Dunkellin River and Aggard Stream Flood Relief Scheme

Response to Numerics Warehouse Report

Client:	Galway County Council
Project Title:	Dunkellin River and Aggard Stream Flood Relief Scheme
Document Title:	Response to Numerics Warehouse (on behalf of Clarinbridge Oyster Co-Op and Michael Kelly Shellfish Ltd.)
Document No:	MGE0260RP0019

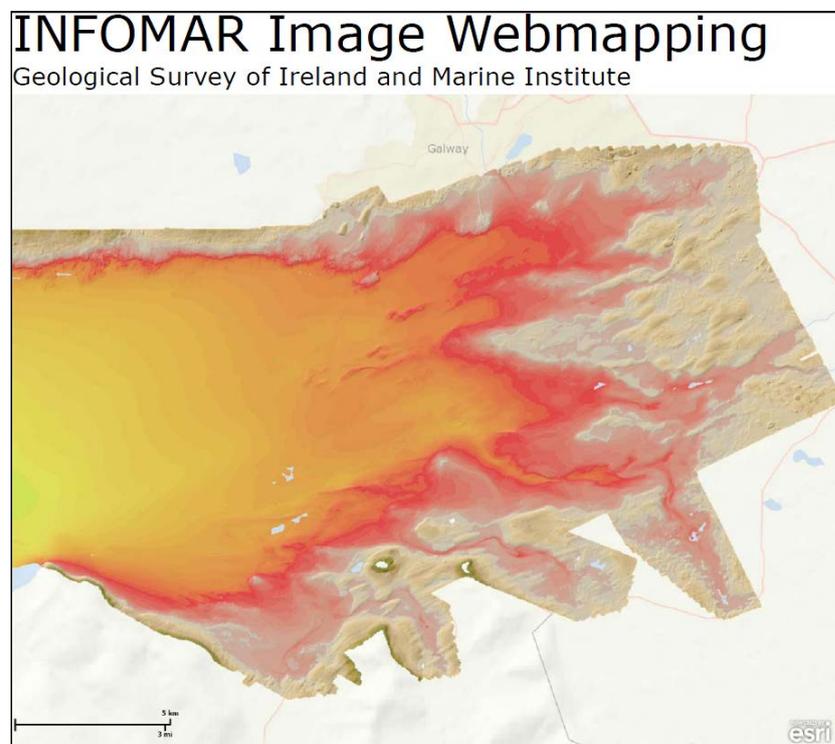
- 1.5** *An accurate bathymetry is critical for the proper maintenance of the model. The authors state that they have used INFOMAR data to establish their model bathymetry. Can they be more precise please? – since INFOMAR multibeam swath bathymetry does not in general extend into waters shallower than 20 m depth and so could not be used for most of the area of interest – the Dunkellin estuary. Did the authors use LIDAR data instead? If so can they please show the coverage of the area of this data. It seems likely to us that the authors have used data much older than INFOMAR data for this modelling problem, with all attendant problems in accuracy this would entail. Some of this data may be more than 100 years old (hand held line measurements) and the contemporary estuarine shape will likely to be very different.*

From EIS **Appendix E** - Environmental Modelling Report: “The source of the bathymetric data was the latest survey and Lidar data provided by INFOMAR which extended across the entire domain.” Figure 2.1 of aforementioned Report shows the extent of the bathymetry. This data was the most up-to-date information at time of writing. The data coverage available from INFOMAR for the Galway Bay area is shown below.
